# Technical Bulletin

No: TCM-0091-B  
ITCM-0068-B

**Product:** CRCS, MCS, and RCS models

**Issue:** New manufacturing numbers / new parts

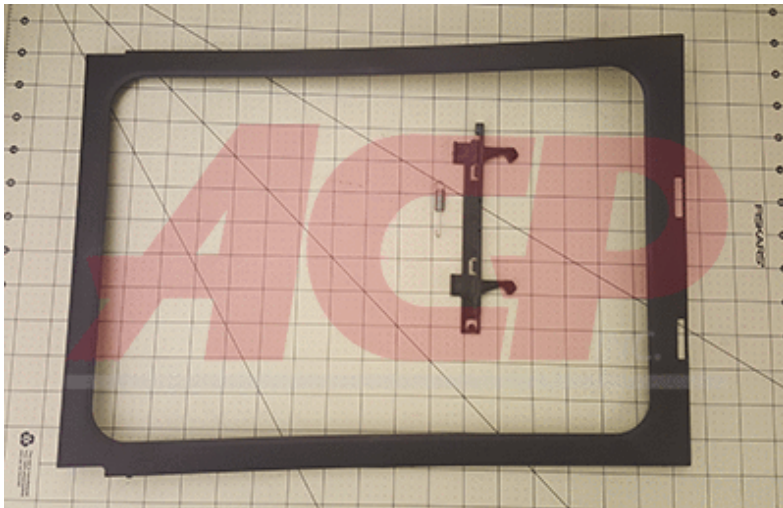
- 14154101 KIT, SPRING/LATCH/CHOKE COVER  
**NOTE:** This kit is **NOT** backward compatible with 14124068

- 54157099 DOOR ASSY-AM (Amana brand)  
**NOTE:** This assembly **IS** backward compatible with previous manufacturing numbers and will replace 54127020
- 54157101 DOOR ASSY- MM (MenuMaster brand)  
**NOTE:** This assembly **IS** backward compatible with previous manufacturing numbers and will replace 54127022
